TRANS/WP.29/837
23 January 2002

World Forum for Harmonization of Vehicle Regulations (WP.29)

DRAFT SUPPLEMENT 2 TO REGULATION No. 107

(Double-deck large passenger vehicles)

A5.7.4. Access to escape hatches

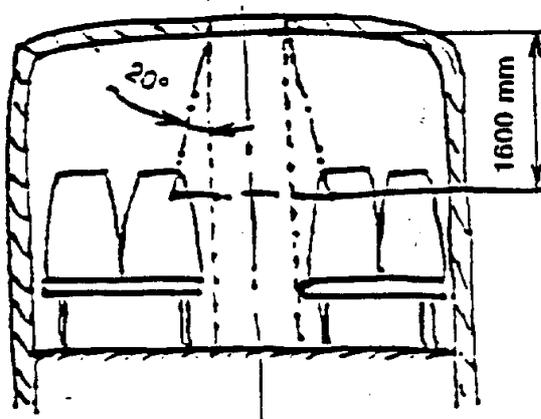
Paragraph 5.7.4., amend to read:

5.7.4.1. If one or more escape hatches are fitted in the roof, at least one escape hatch shall be located such that a four-sided truncated pyramid having a side angle of 20° and a height of 1,600 mm touches part of a seat or equivalent support. The axis of the pyramid shall be vertical and its smaller section shall contact the aperture area of the escape hatch. Supports may be foldable or movable provided they can be locked in their position of use. This position shall be taken for verification.

5.7.4.2. When the structural thickness of the roof is more than 150 mm, the smaller section of the pyramid shall contact the aperture area of the escape hatch at the level of the outside surface of the roof.®

Figure 11

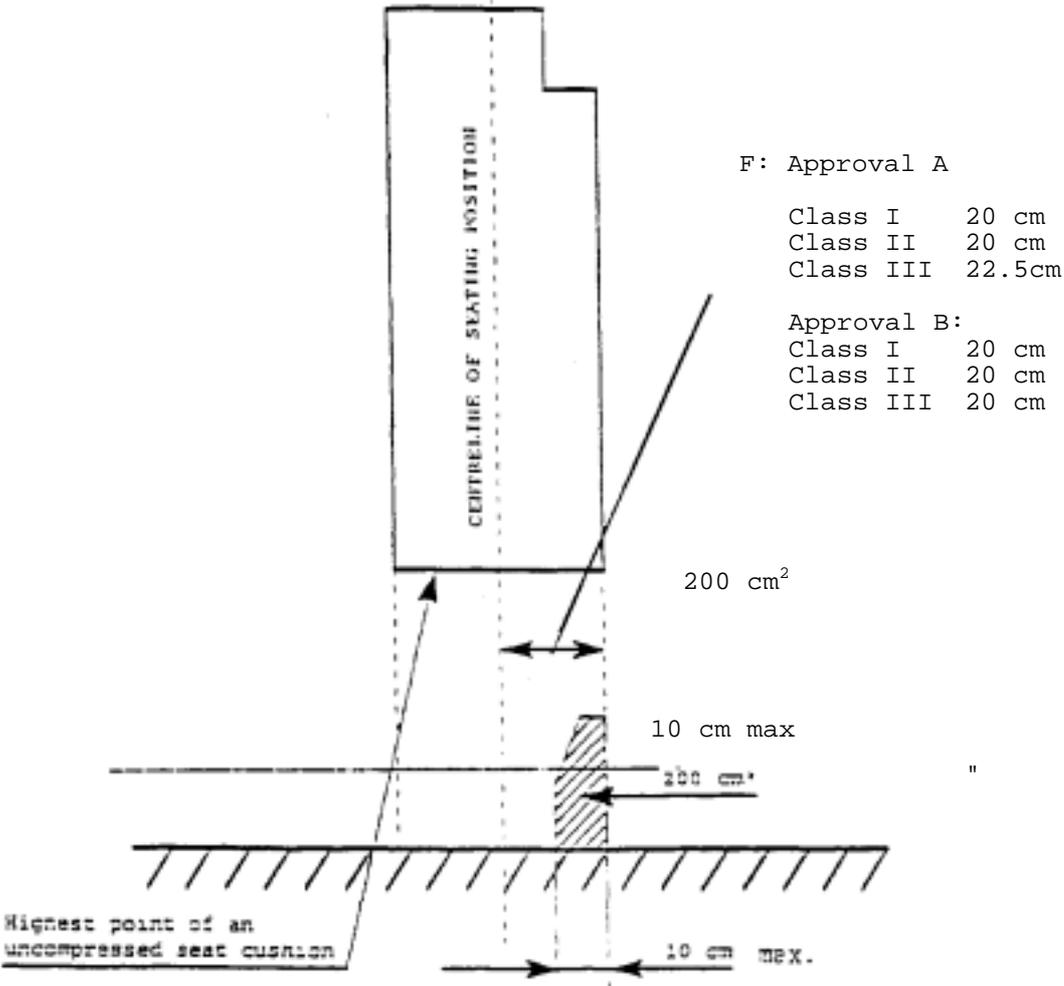
Annex 3, figure 11, replace by the following figure:

PERMITTED INTRUSION IN LOWER PART OF PASSENGER SPACE
(See paragraph 5.7.9.6.2.3.)
